SEPTIC IMPROVEMENT PERMIT / AUTHORIZATION TO CONSTRUCT / OPERATION PERMIT / EXISTING SYSTEM

APPLICANT/OWNER: Robert Pippin | APPLICANT ADDRESS: 127 Bayberry Creek Circle Mooresville, NC

BOB PIPPIN - RELAYOUT TO SAVE WHITE OAK TREE - 4-27-20
MUST BE APPROVED + PERMITTED BY ICHD

Limited Relayout To Save Oak Tree

AS BUILT SKETCH

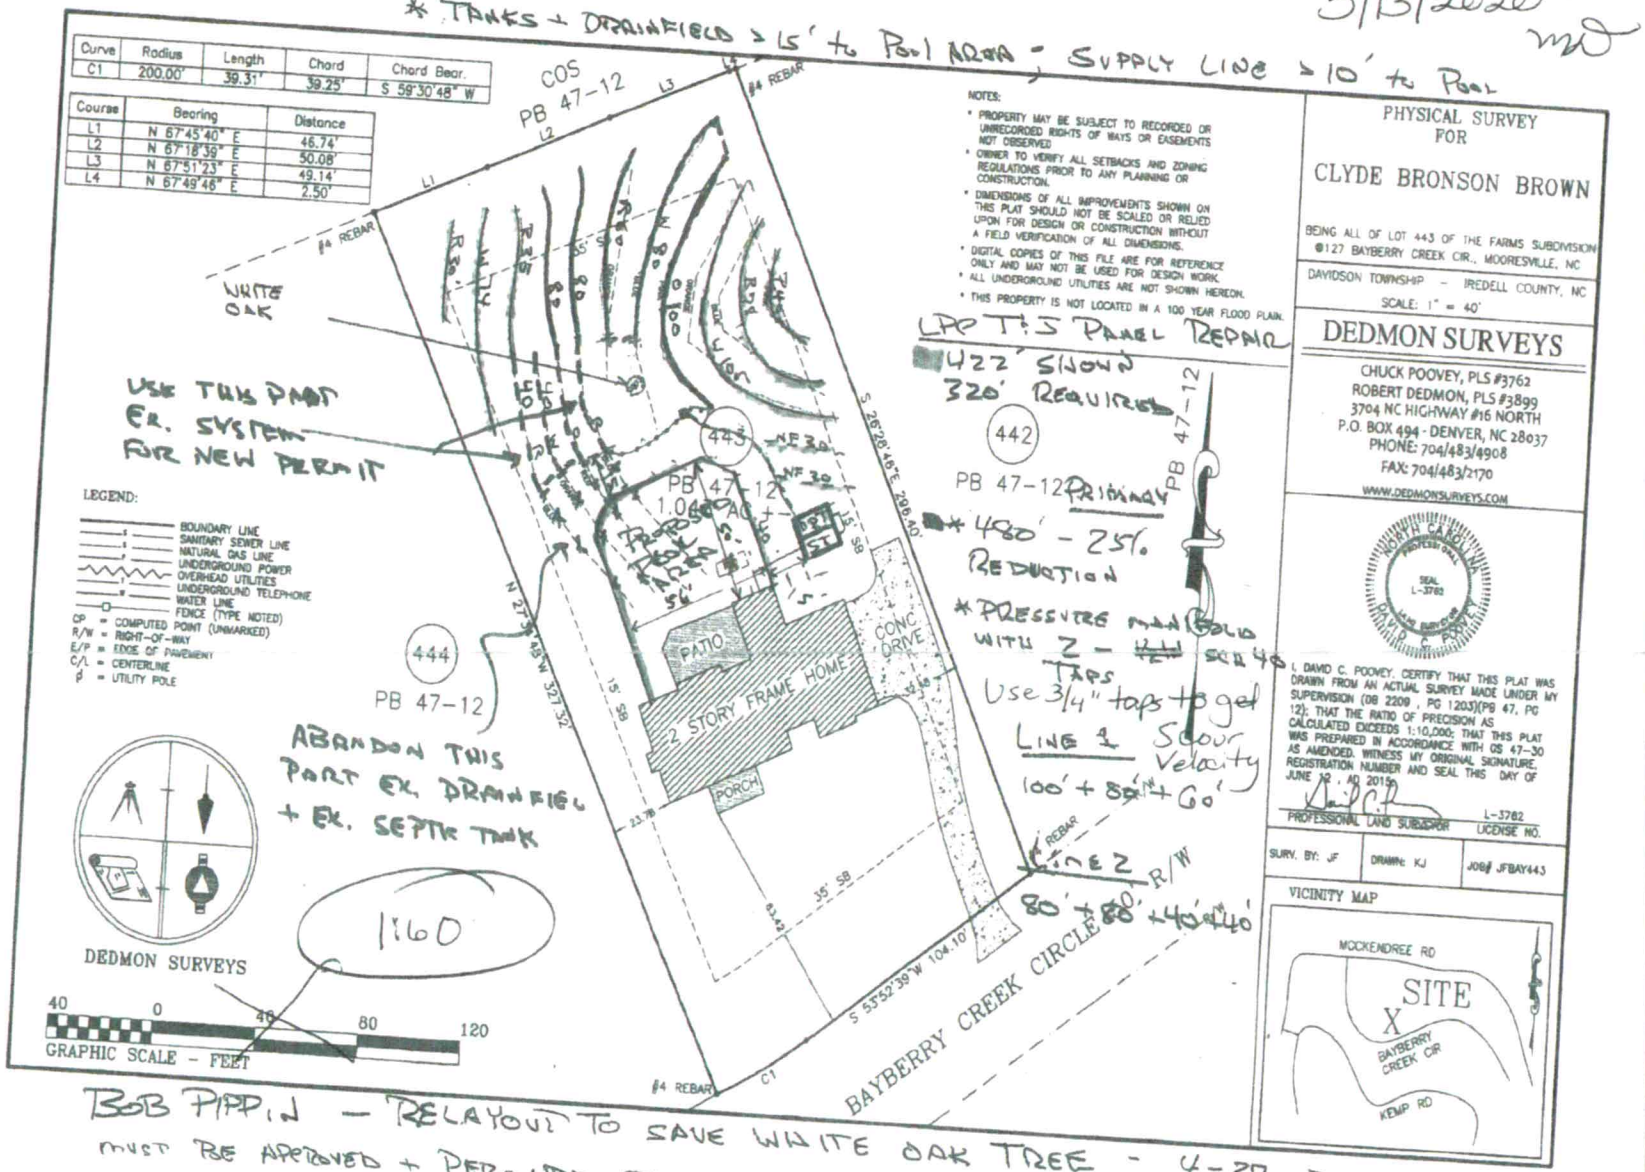
First line 94' 7' ftp/c
2-82'
3-62'

Need to move end of 94' to 82'

PHYSICAL SURVEY FOR
CLYDE BRONSON BROWN
BEING ALL OF LOT 443 OF THE FARMS SUBDIVISION @127 BAYBERRY CREEK CIR., MOORESVILLE, NC
DAVIDSON TOWNSHIP - IREDELL COUNTY, NC
SCALE: 1" = 40'

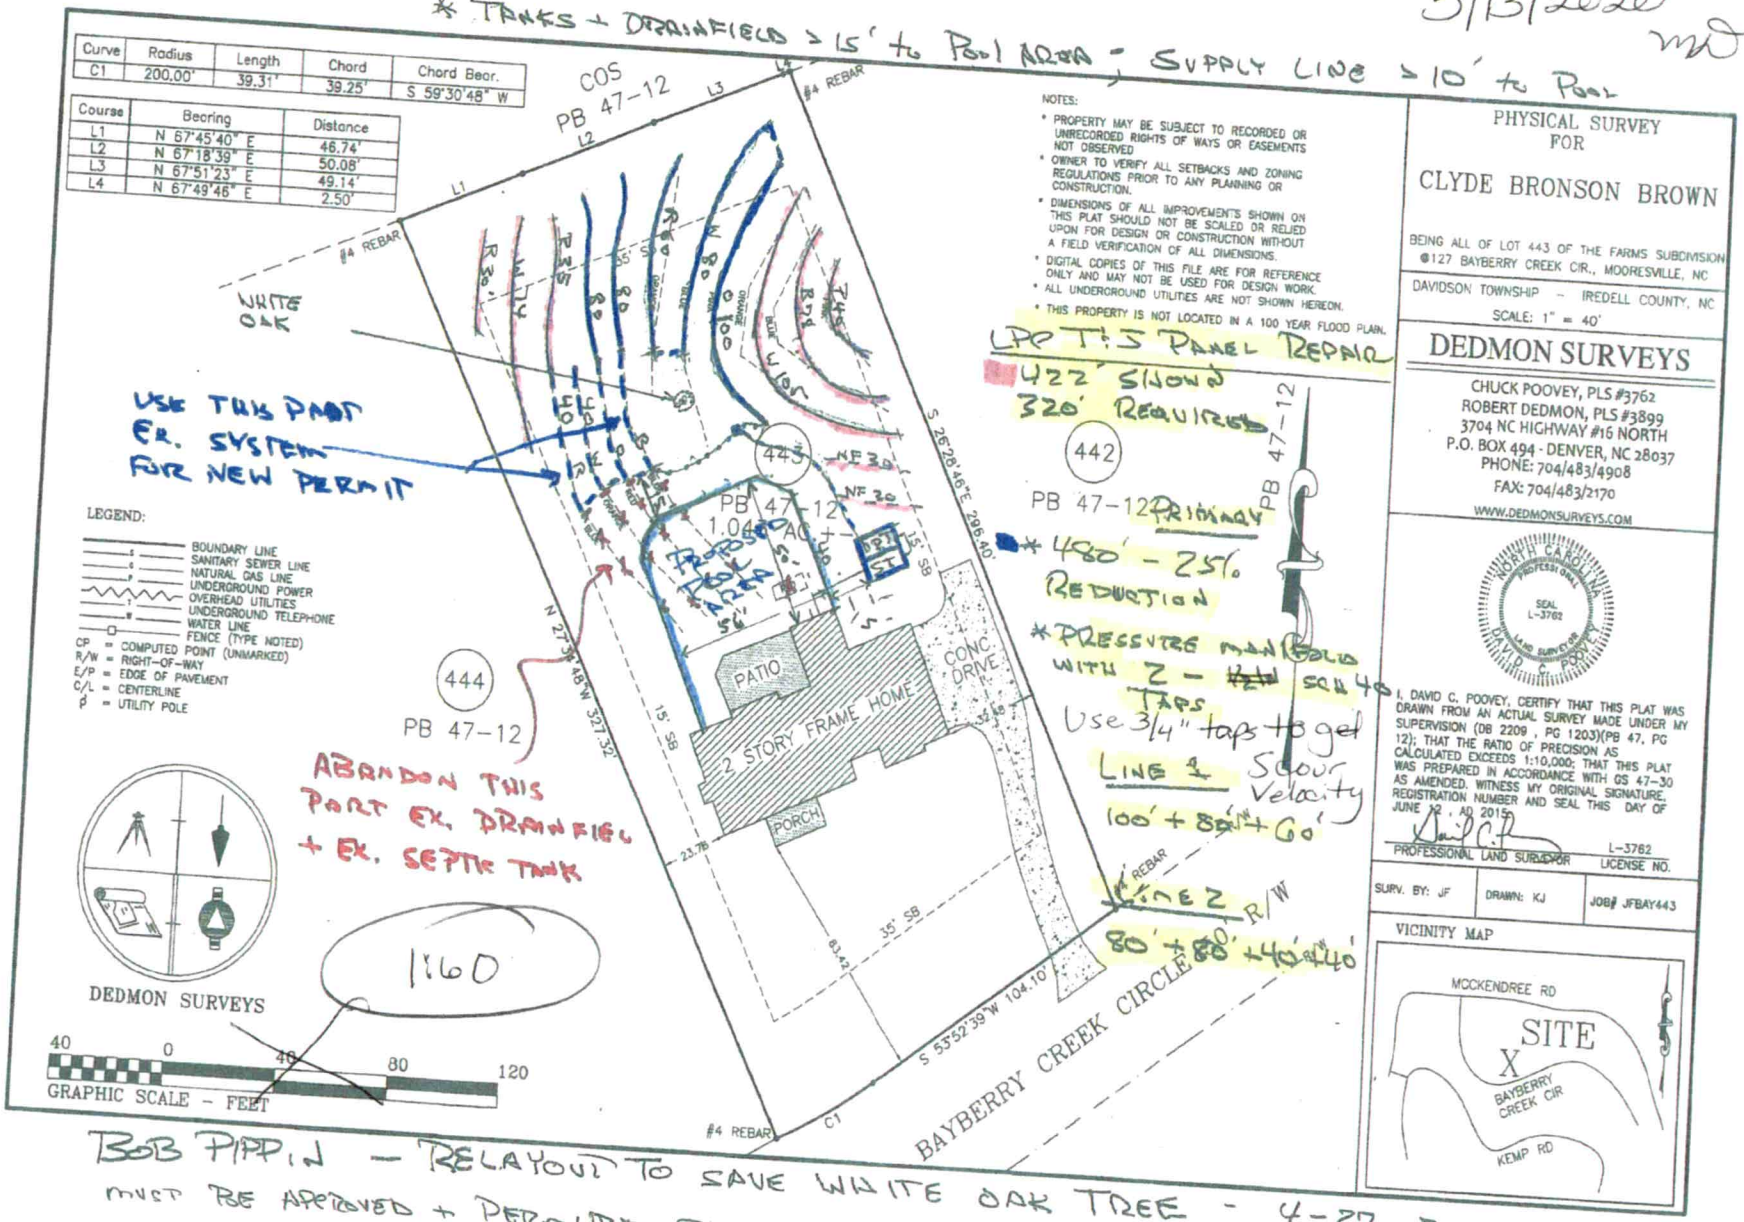
* TANKS + DRAINFIELD > 15' to POOL AREA - SUPPLY LINE > 10' to POOL

LAP T-5 PANEL REPAIR
422' SHOWN
320' REQUIRED
442
PB 47-12
PRIMARY
* 480' - 25% REDUCTION
* PRESSURE MANIFOLD WITH 2 - [illegible] SCH 40 TAPS
Use 3/4" taps to get LINE 1 Scour Velocity
100' + 80' + 60'
LINE 2
80' + 80' + 40' + 40'

PHYSICAL SURVEY
FOR
CLYDE BRONSON BROWN

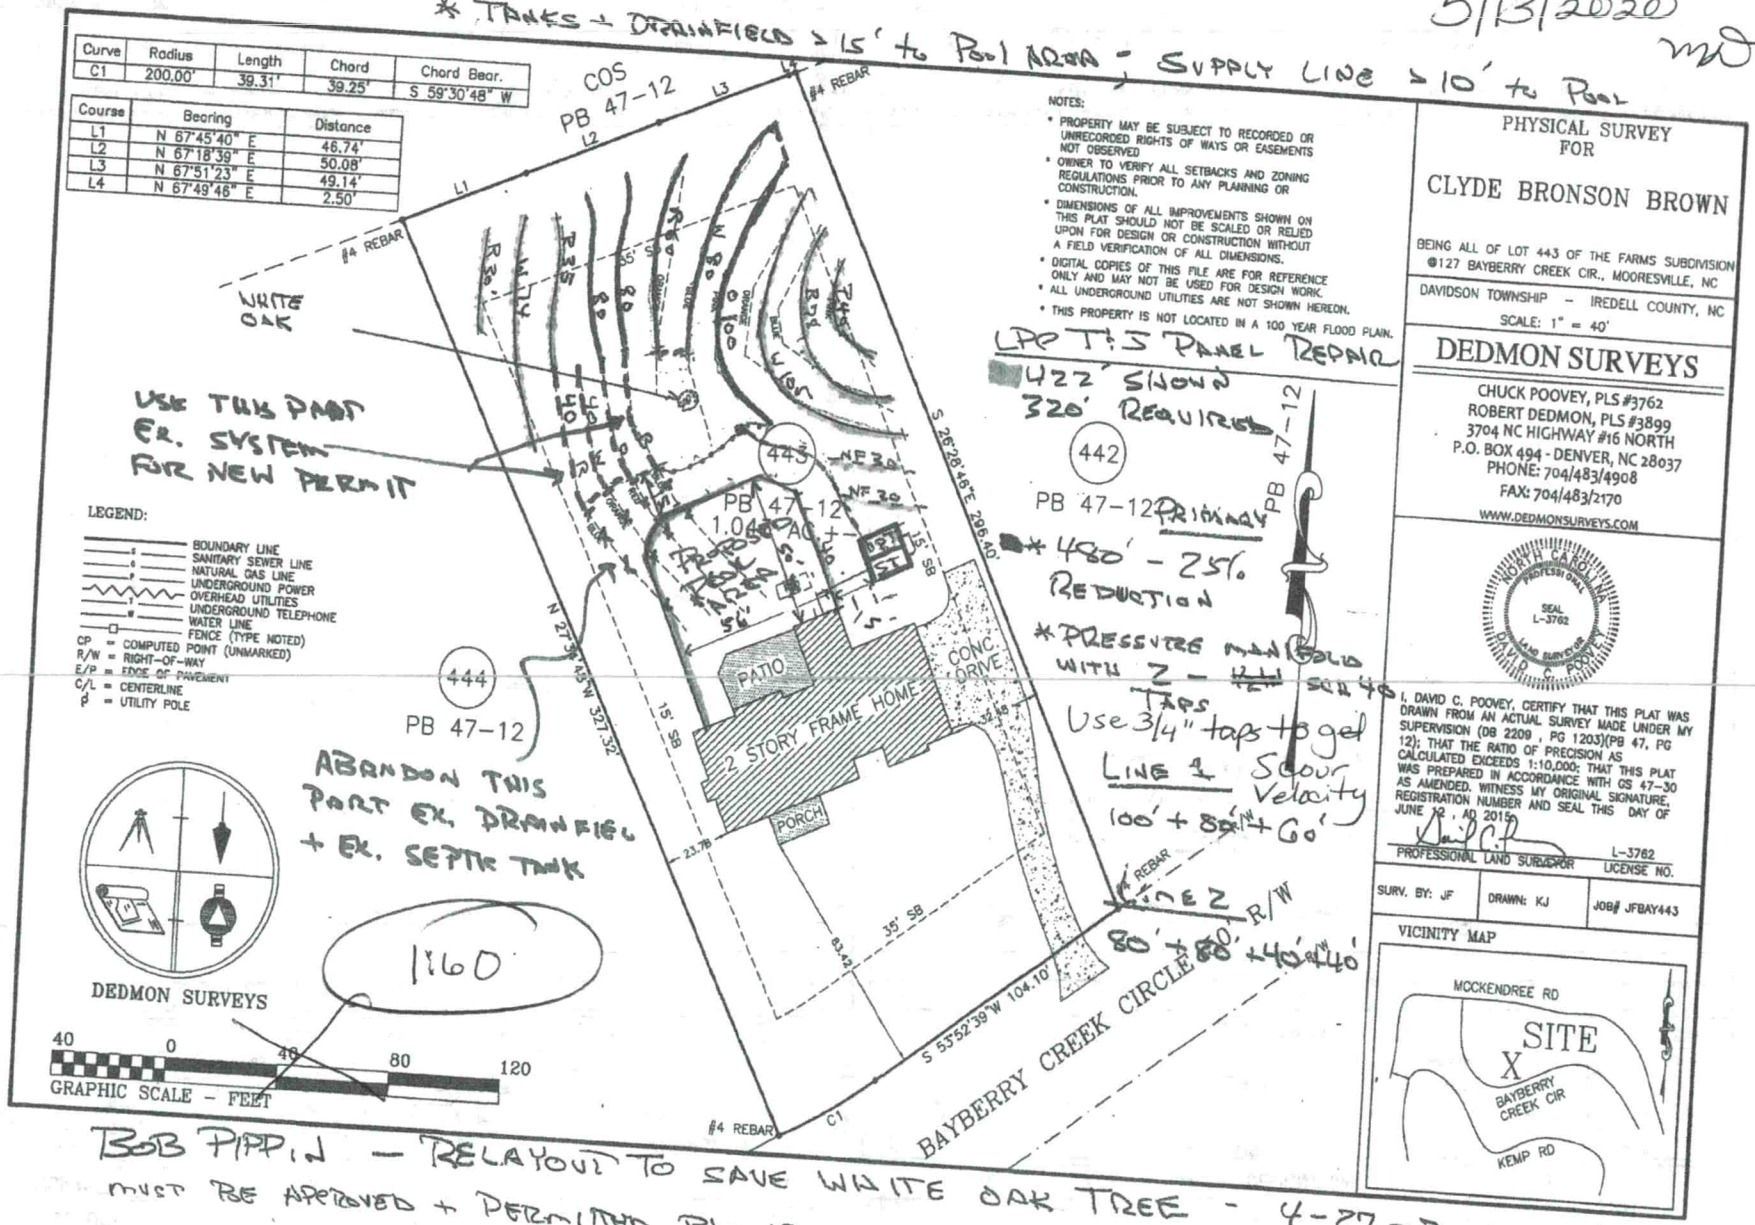
LPP T.S PANEL REPAIR

422' SHOWN
320' REQUIRED

* 480' - 25% REDUCTION

* PRESSURE MANIFOLD WITH 2 - 1" SCH 40 TAPS
Use 3/4" taps to get Scour Velocity

LINE 1
100' + 80' + 60'

LINE 2
80' + 80' + 40' + 40'

PHYSICAL SURVEY FOR
CLYDE BRONSON BROWN
BEING ALL OF LOT 443 OF THE FARMS SUBDIVISION @127 BAYBERRY CREEK CIR., MOORESVILLE, NC
DAVIDSON TOWNSHIP - IREDELL COUNTY, NC
SCALE: 1" = 40'

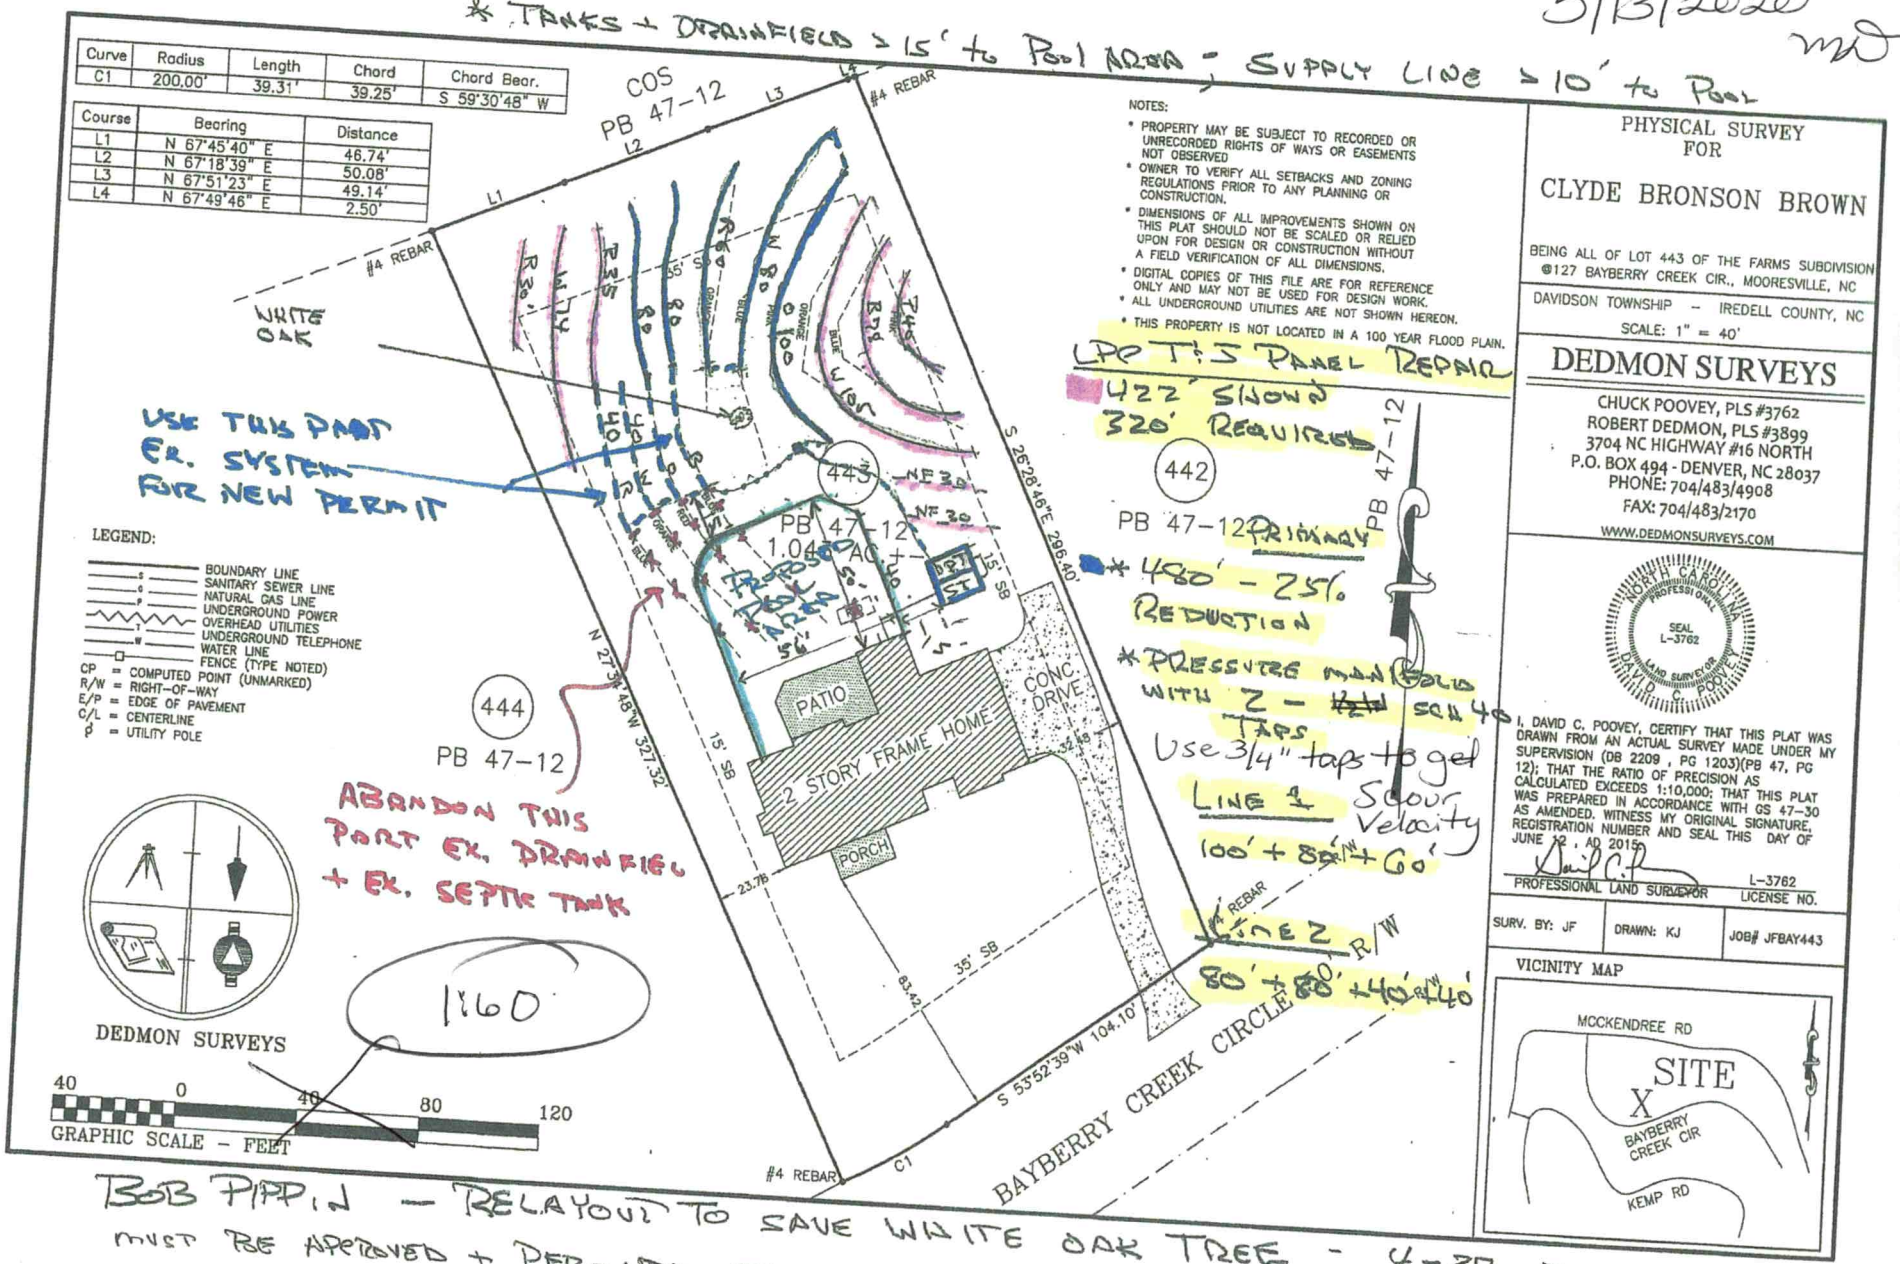
BOB PIPPIN - RELAYOUT TO SAVE WHITE OAK TREE - 4-27-20
MUST BE APPROVED + PERMITTED BY ICHD

* TANKS + DRAINFIELD > 15' to Pool Area - SUPPLY LINE > 10' to Pool

LPP T.S PANEL REPAIR
422' SHOWN
320' REQUIRED
PRIMARY
* 480' - 25% REDUCTION
* PRESSURE MANIFOLD WITH 2 - ~~1"~~ SCH 40 TAPS
Use 3/4" taps to get Scour Velocity
LINE 1
100' + 80' + 60'
LINE 2
80' + 80' + 40' + 40'
R/W
